Issue No. 1

Can the building be lowered by 8 Feet to permit a view of the horizon at Oakland to the south.

Section Diagram
Showing Required Heights

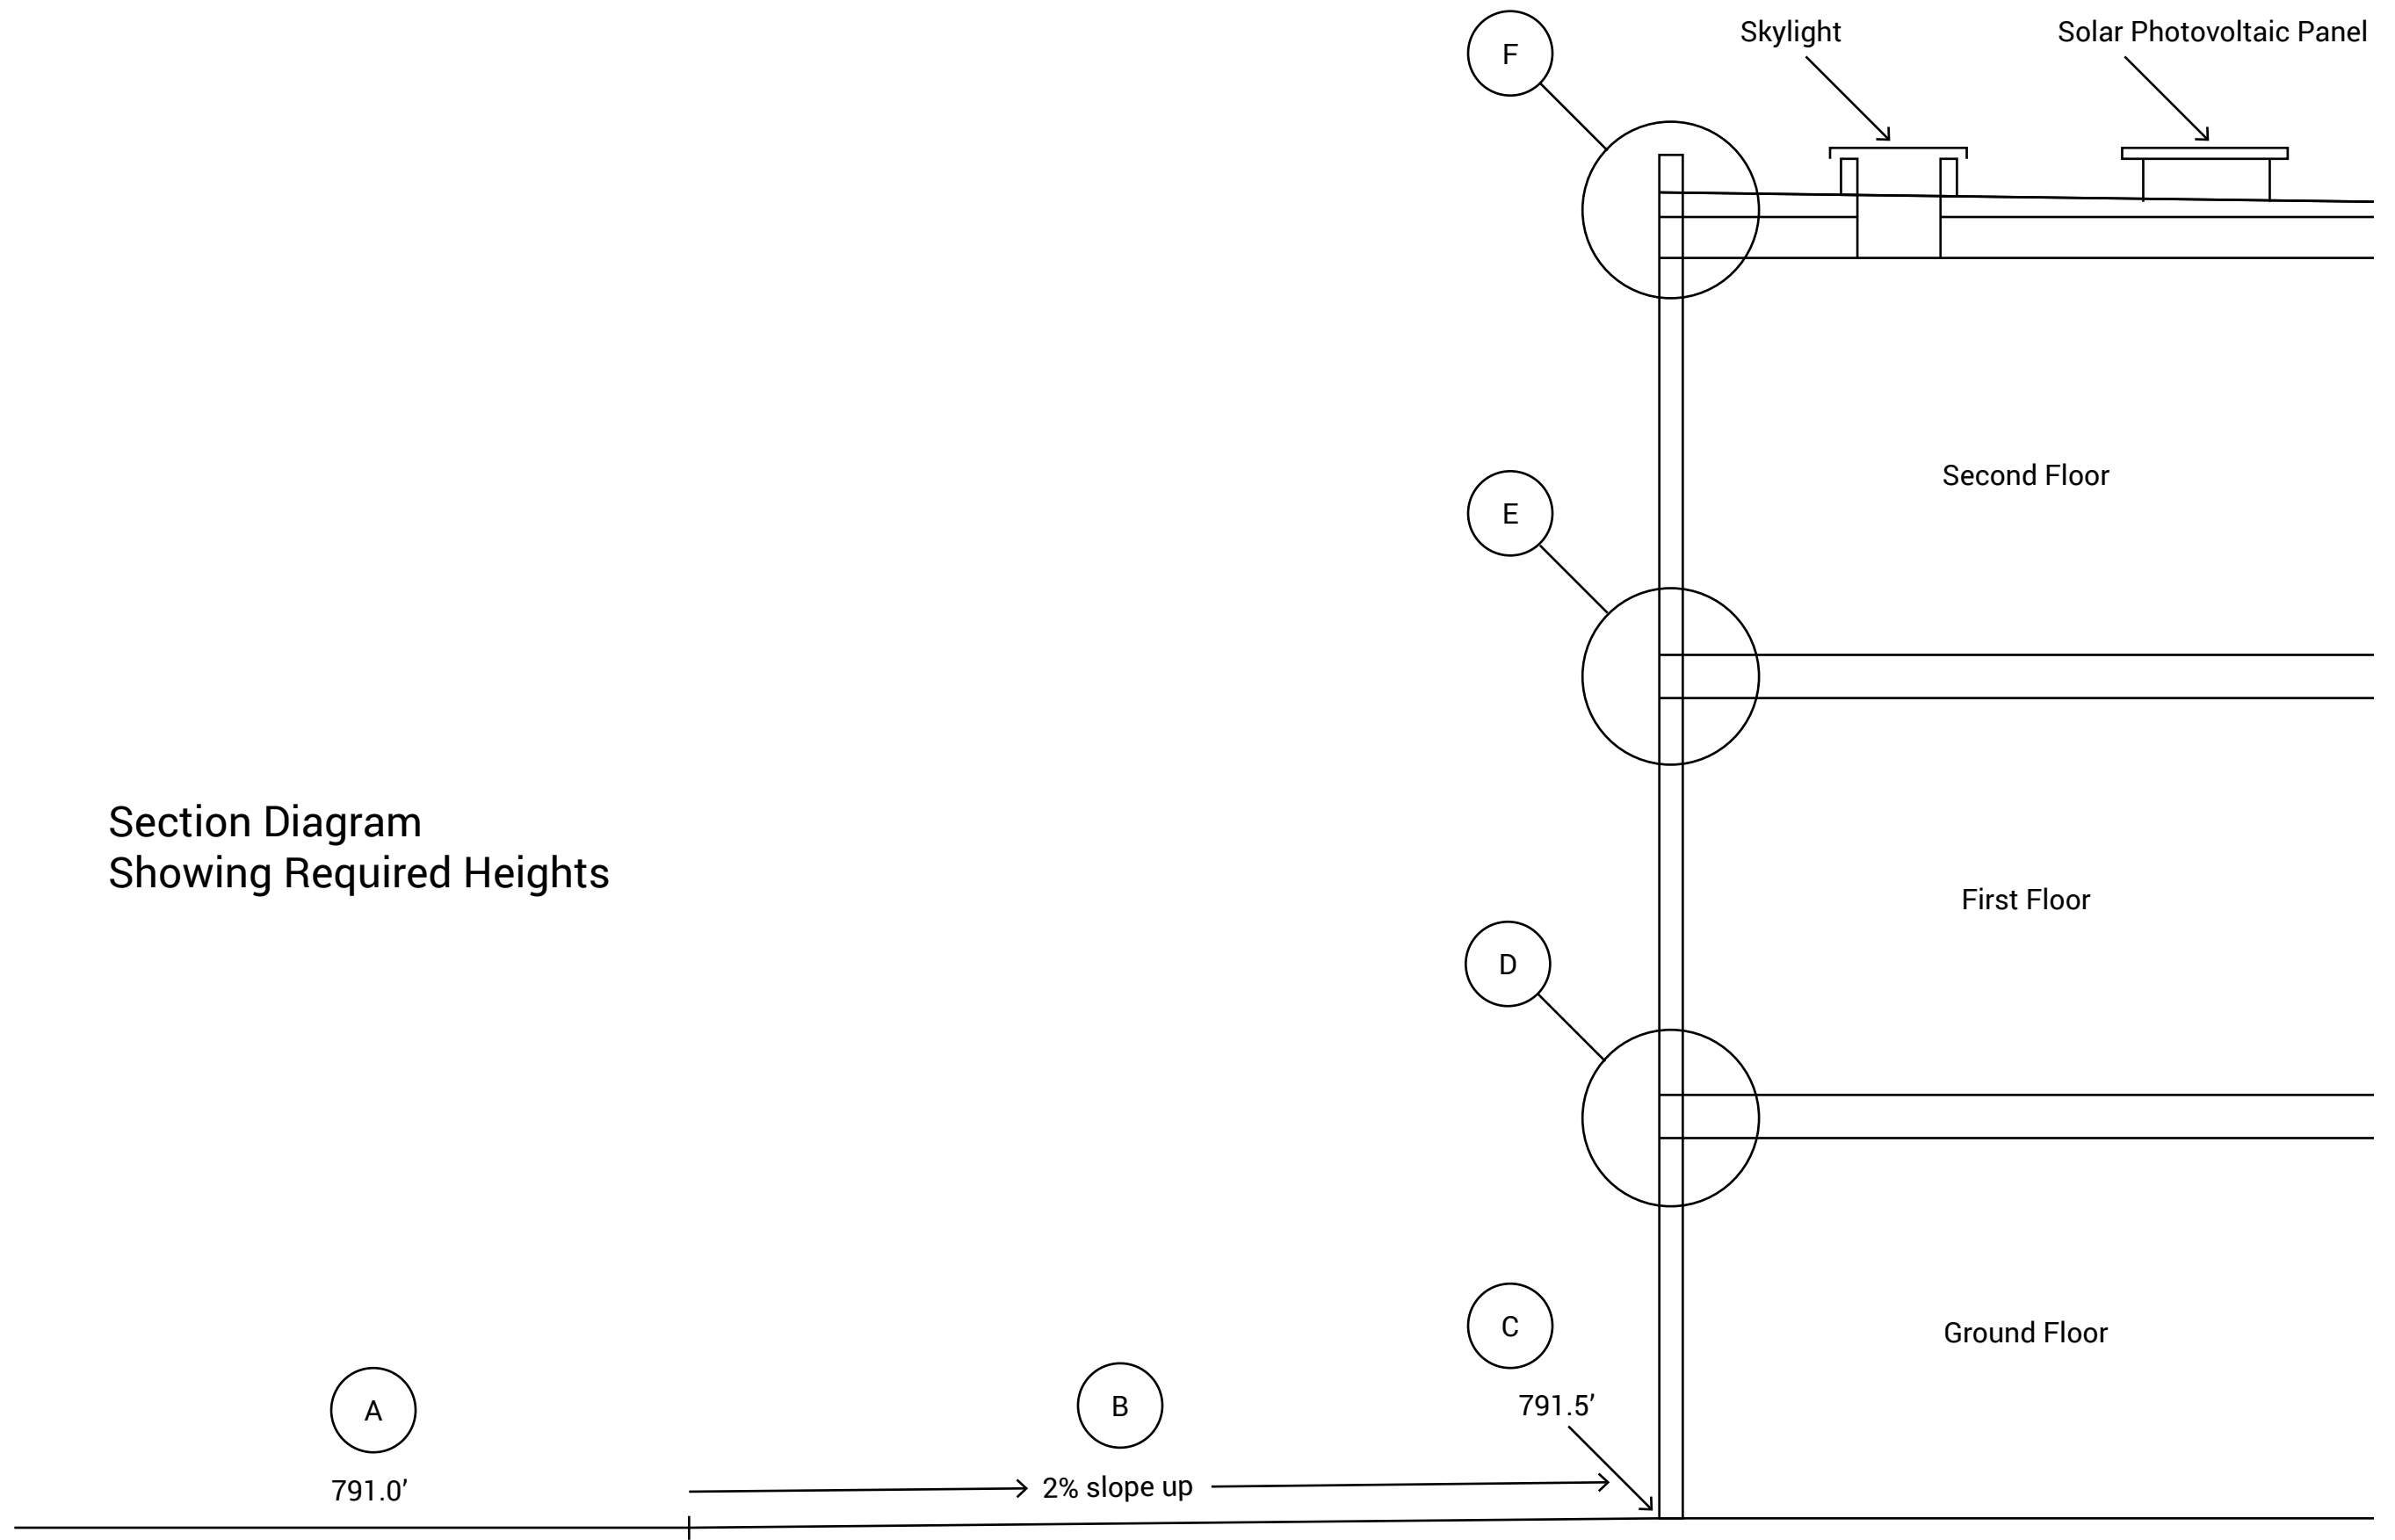
Luk has proposed a steeper driveway, thinner floors and roof, minimum roof slope, elimination of the parapet, and reduced ceiling heights to accomplish the 8-foot reduction. It should be noted that 8 feet is the minimum reduction required to expose the view. Anything less than that and the view of the horizon remains not visible. This corresponds to a top-of-parapet elevation of 820'-0". (The proposed design is 828'-0".)

Refer to the diagram, *Section Diagram Showing Required Heights*, for the complete analysis, with following specific comments:

A Because of the strong constraints of site geometry and site topography, there is only one way to get a car on to the site and turned to park under a rain-protected structure, with accessible entry to the house. That is accomplished with a sloping driveway within a fixed distance and turning area (for entry to and exit from the site) as shown in the original Plot Plan. The only question is the steepness of ramp.

B The parking area next to the lowest level, the Ground Floor, must drain away from the house with a 2% slope.

C The elevation of the ground floor, which must be accessible and therefore at the same elevation as the immediately adjacent grade, is 791'-6". (2% slope over 23'). We address the ceiling height when all the remaining issues have been addressed.

Luk has proposed a design that has the bottom of the ramp at 791'-0". This is 2' lower than the original design of 793'-0". I've consulted with my civil engineer and he advises that this code maximum, though steeper, is within acceptable design. We therefore acknowledge the proposed lower elevation for this analysis though we prefer the less steep option, especially when exiting the site.

The diagram therefore begins with the elevation of the bottom of the ramp at 791'-0".

Adding the elevation of the Ground Floor to the thicknesses of First Floor, Second Floor and Roof assemblies, yields 796'- ¼". As the architect for the Luks said, the minimum acceptable ceiling height in modern homes is 9'-0". This includes the Ground Floor, since it will be an occupied floor, not a "basement room". However, even if we were to assign 8 ft to the ceiling of the Ground Floor, the total of the three ceiling heights would be 9 + 9 + 8 = 26'. Added to the 796'- ¼", the lowest elevation that is possible technically is 822'- ¼", still 2 feet short of the minimum required.

The 8-foot reduction cannot be reasonably accomplished, even if these minimum ceiling heights were acceptable. (Acceptable to us would be minimally 9.5', 9.5', 9.0', for a total of 28.0')

The view of the horizon to the south from the corner of the rear of the Luks' house cannot technically be maintained if a two-story house is built at 158 Lawson Road. Conversely, a two-story house cannot be built on 158 Lawson Road if it is required to maintain that view.

Detail at D
1 1/2" = 1'

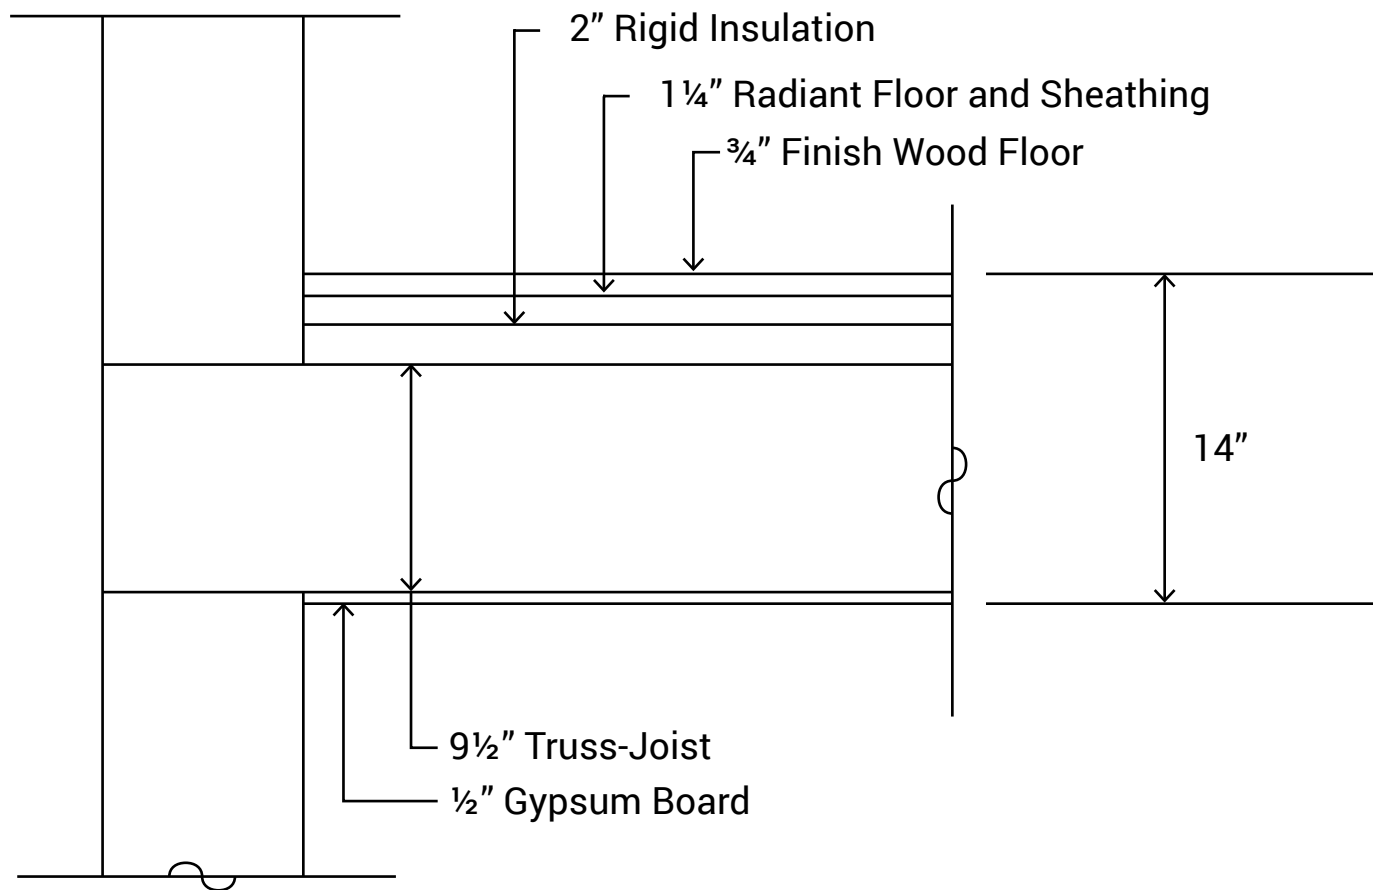
D (Refer to "Detail at D".) I consulted with my structural engineer concerning the use of 9½" truss joists. In general, the beams required are deeper than 9½". Use of the 9½" truss joists would mean the beams protrude below the ceiling. A solution that avoids this is the use of steel beams, a more expensive solution. However, aside from the added cost, it is technically feasible to obtain a thinner floor thickness using 9½" joists. We therefore acknowledge the use of 9½" joists in the floor assemblies for this analysis, though we prefer the less costly floor assemblies of the original design.

We note that the floor assemblies utilize radiant floor panels, "Warmboard", which requires the sheathing layer to be 1¼" to accommodate the plastic tubing. (This is a *Zero Net Energy* house, and this is a feature of such houses.) In addition, there must be a 2" insulation layer in order to insulate the warmboard from the unheated rooms below (and the ground where it occurs)

The total thickness of the floor assembly at the First Floor (D) is 14".

Detail at E
1 1/2" = 1'

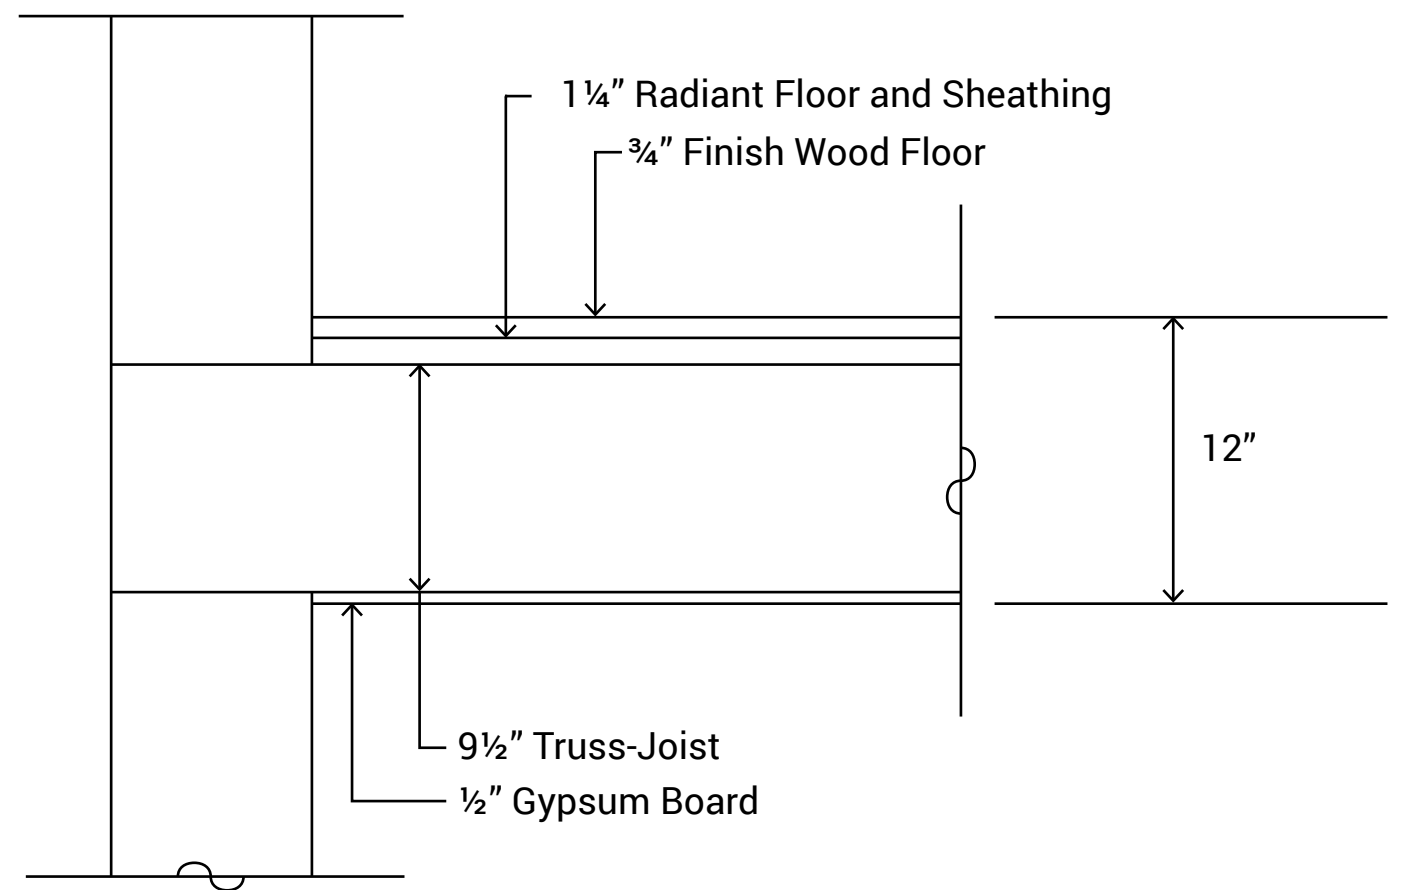
E (Refer to "Detail at E".) Again, this diagram accepts the use 9½" truss joists and steel beams for the floor assembly since it is technically possible (though more expensive). Warmboard Is required, though the insulation is not.

Therefore, the total thickness of the floor assembly at the Second Floor (E) is 12".

Detail at F
1 1/2" = 1'

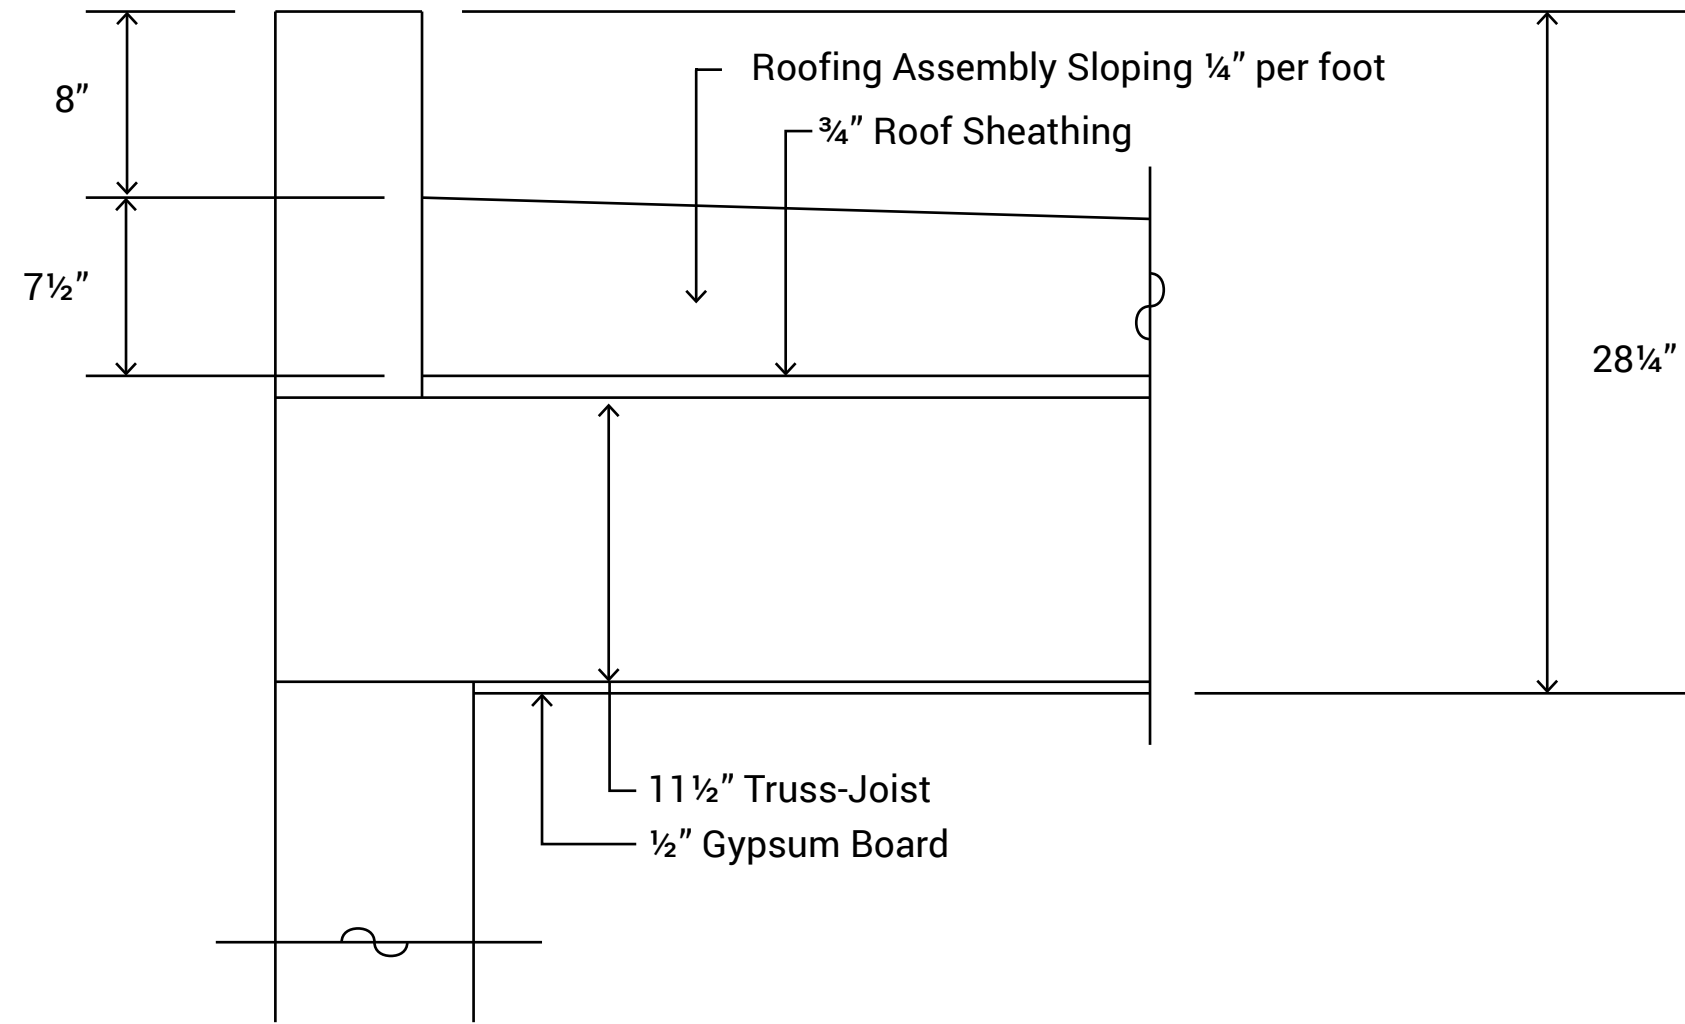
F Refer to the main diagram. Because the skylights and solar photovoltaic panels are at least 12" higher than the roof or several inches higher, and are placed on the roof in the general direction of the view in question, the height of the parapet is technically irrelevant with regard to blockage of the view in question. The skylights and support structure for the solar photovoltaic panels would still block the view. (Furthermore, good practice with regard to waterproofing, I believe as a practicing architect of 35 years, requires a minimum parapet height for flashing and counter-flashing.)

(Refer to "Detail at F".) Because of the longer spans, the depth of the truss joists is 11½".

There is a built-up layer of roofing assembly (waterproofing and shaped Styrofoam) which provides the minimal drainage of ¼"-per-ft slope over the 30-foot width of the house. That is done so that rainwater is efficiently collected on one side of the house and piped to a cistern for storage in the utility room. (This is the rainwater gray water system used for landscape irrigation.) The thickness of this sloping assembly is 7½" at the upper end and 0 at the other. The parapet height will vary from a minimum of 8" to a maximum of 15½", though the top-of-parapet elevation remains constant. In any event, the top-of-parapet elevation is less than the height of the skylights or the height of the supporting structure for the solar photovoltaic panels.

Therefore, we do not acknowledge the reduction of parapet height as having any effect on the ability to see the horizon.

Therefore, the total thickness of the overall roof assembly is 28¼".
